December 21, 2015

Final Development Plan

#201509280073

Farm Banks Way, Grove City

EAST ELEVATION

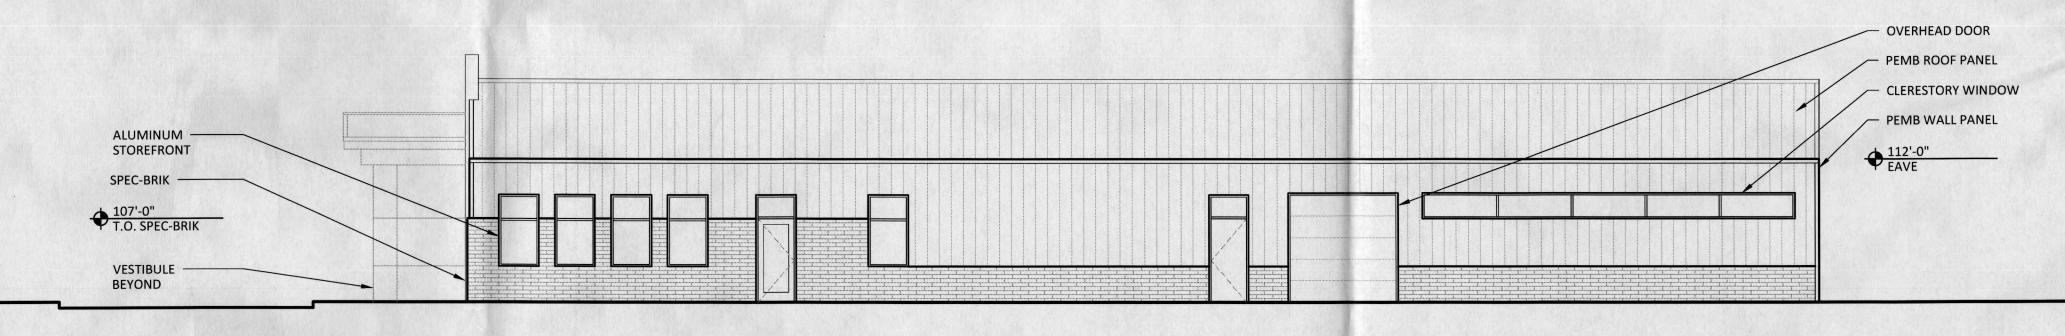
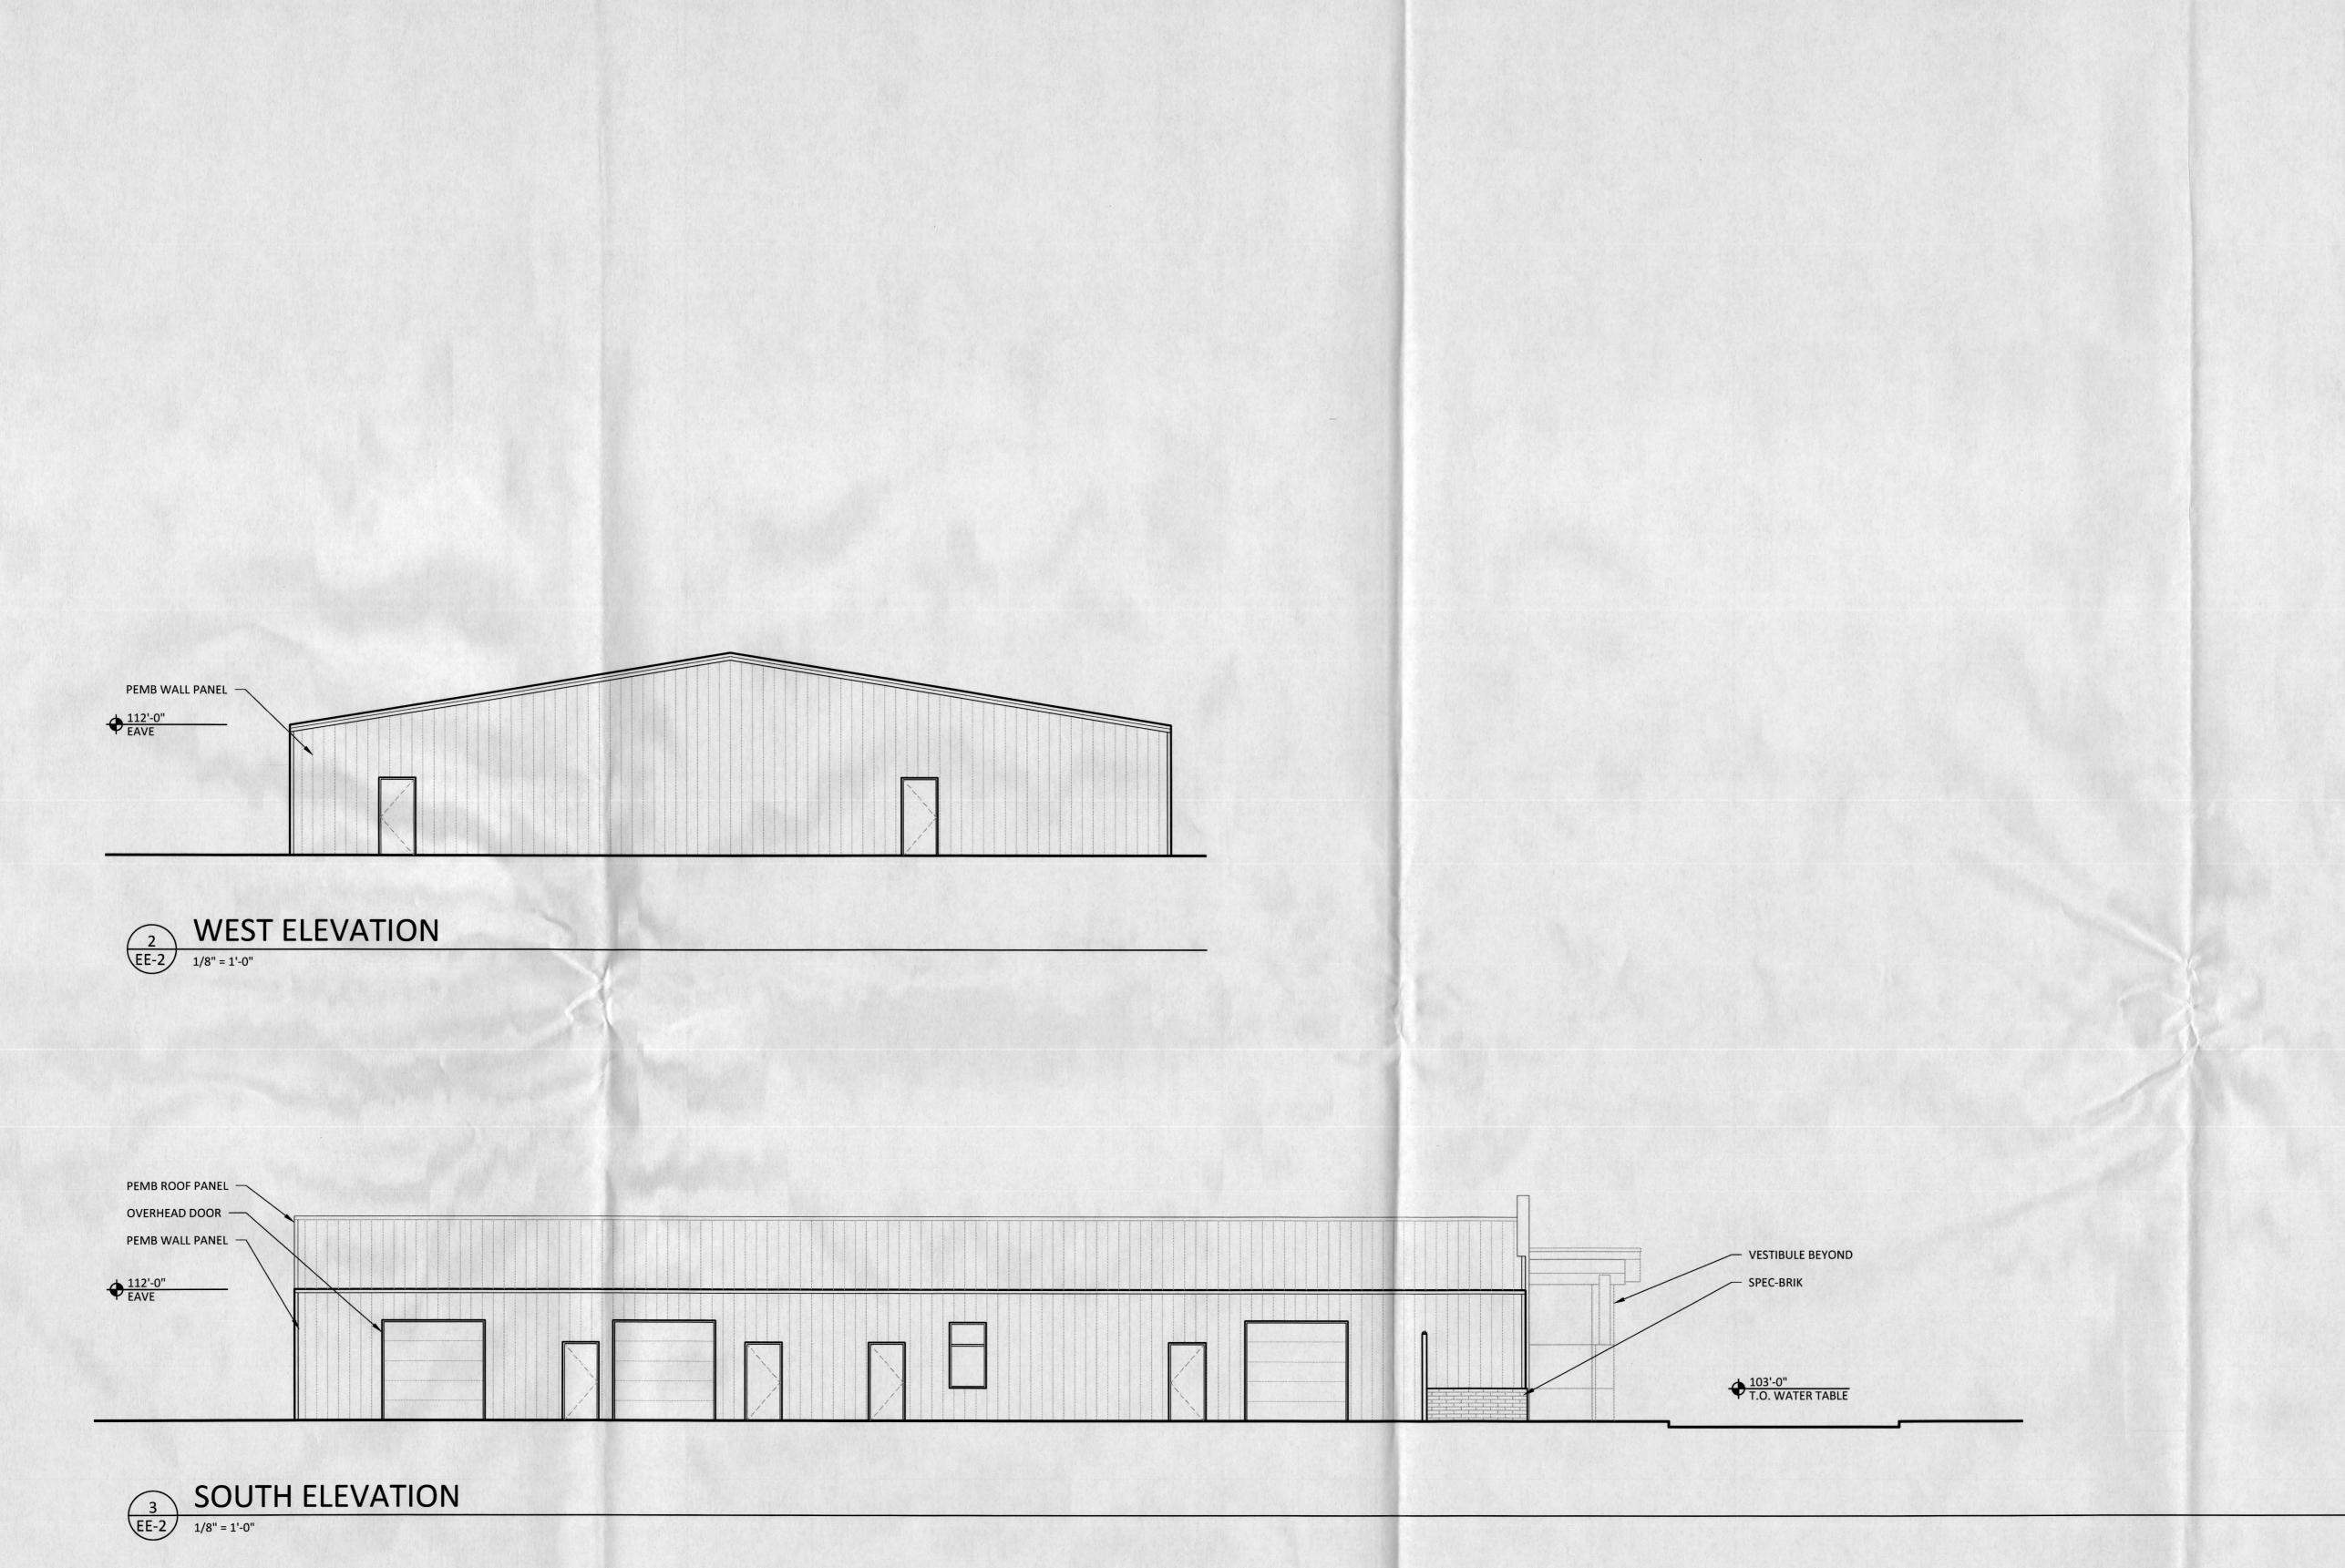
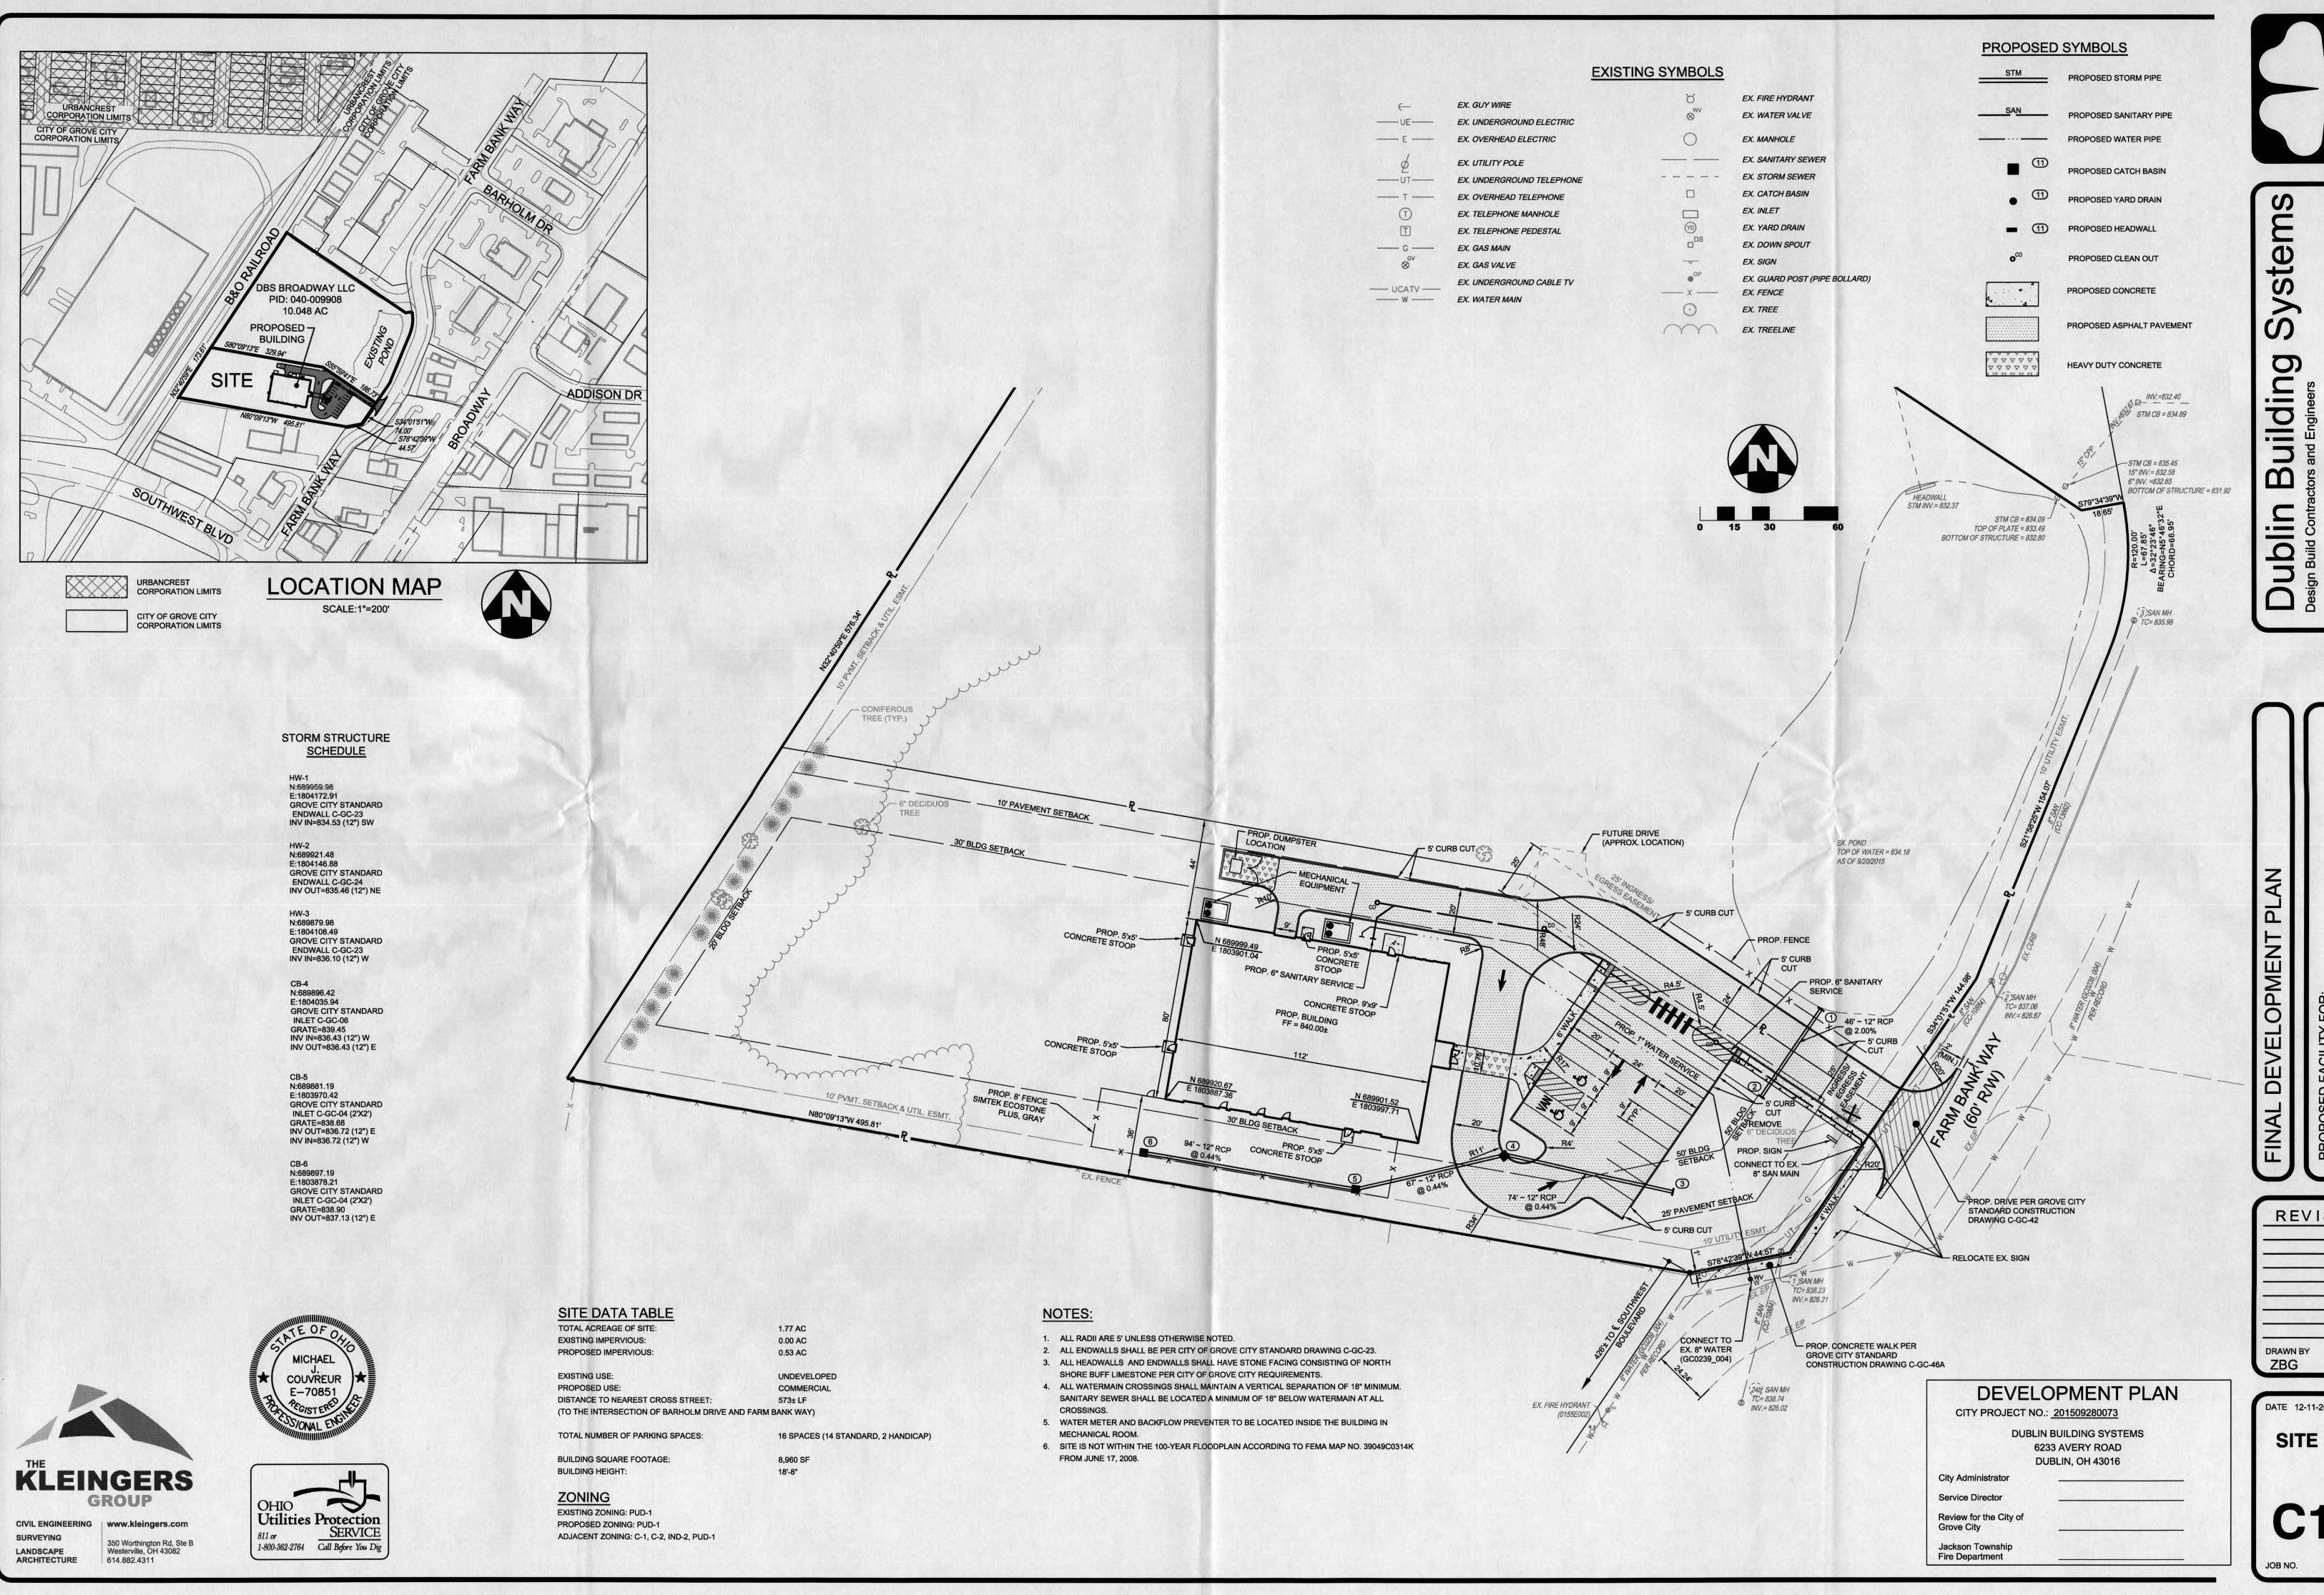
4. The Area Calculation on sheet EE-1 (building elevations) should be expanded to detail all proposed materials on all sides of the structure and the percentage of each on each side as well as overall percentages, to ensure compliance with the architectural standards set forth in the approved zoning text for the site.
Response: The Area Calculations have been expanded to show the percentages of material on each elevation.
